IN THE DRAWINGS:

REMARKS

Amendments to the Drawings

FIG. 11C

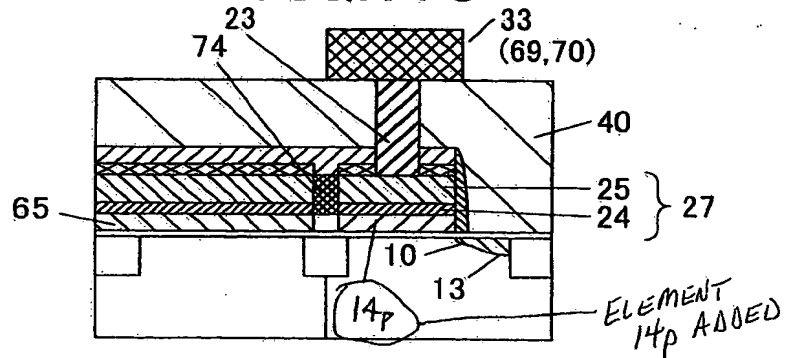
The attached sheet of drawings includes changes to Fig. 11C. This sheet, which includes Fig. 11A-11D, replaces the original sheet including Fig. 11A-11D. In Fig. 11C, numeral "66" has been amended to numeral "14p". An annotated sheet showing the change is also attached. A Letter to the Draftsperson is submitted herewith.

The drawings have been objected to for 1) failing to comply with 37 CFR §1.84(p)(4), because reference characters "14p" and "10p" have both been used to designate p-type region, and 2) failing to comply with 37 CFR §1.84(p)(5), because reference numeral 66 in Figure 11C is not mentioned in the description.

Applicant respectfully submits appropriate amendments have been made to both the drawings and the specification, as requested by the Examiner.
